GROUND STRAP ADDED TO PREVENT OSCILLATIONS

Effective Prod SN B343400

Fig. 1. Location of Added Ground Strap.

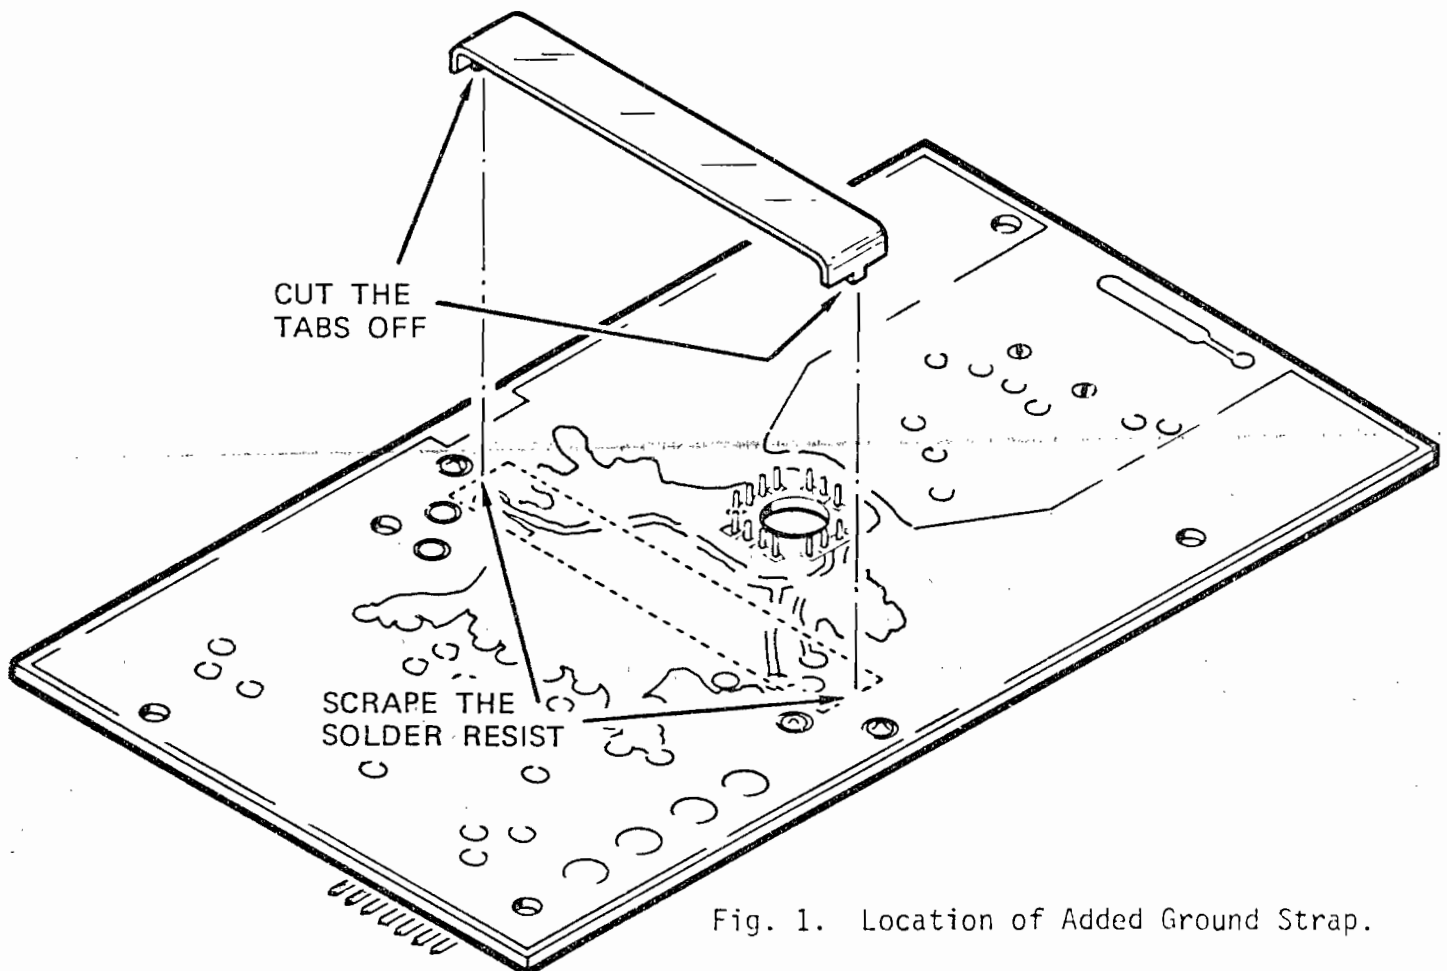
To prevent a wide crt trace and gain compression caused by 1.2GHz oscillations in the Vertical Amplifier, a copper ground strap was added to connect the two major ground planes on the solder side of the A5 Vertical Amplifier circuit board.

The tabs on the ground strap were cut off. The solder resist was scraped off the circuit board in the areas to be soldered and the ground strap was connected between the two major ground planes near the Vertical Amplifier input connectors.

Refer to Fig. 1 and the Remove/Add list for further information.

The new Vertical Amplifier circuit board, pn 670-1958-05, is the same as the old Vertical Amplifier circuit board, pn 670-1958-04, except for:

1 ea 346-0171-00 Strap, grounding, 2.0"L, copper
